CONTRACT  
**PIZZA EXPRESS**  
**30 COPTIC STREET**  
**LONDON**  
**WC1A 1NS**

DRAWING  
**PROPOSED**  
**EXTERNAL SEATING**

DRAWING No 5045/15\_01 REV

SITE PLAN 1:50

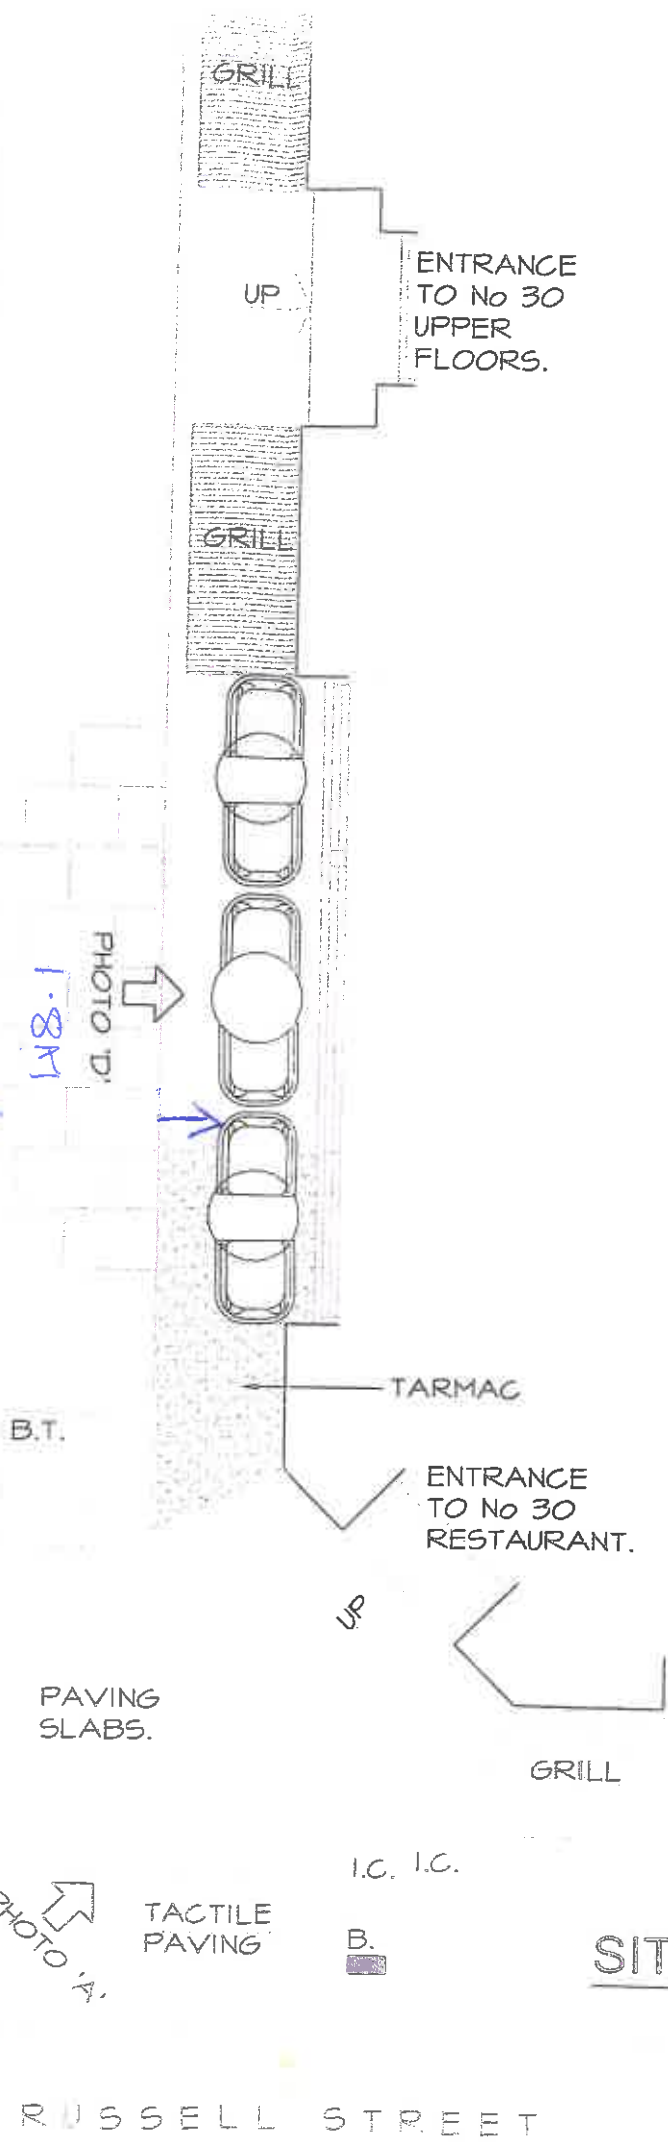
Dimensions of table and chairs is required

Table measurements: 70 x 70cm  
 Chair measurements: 45 x 45cm
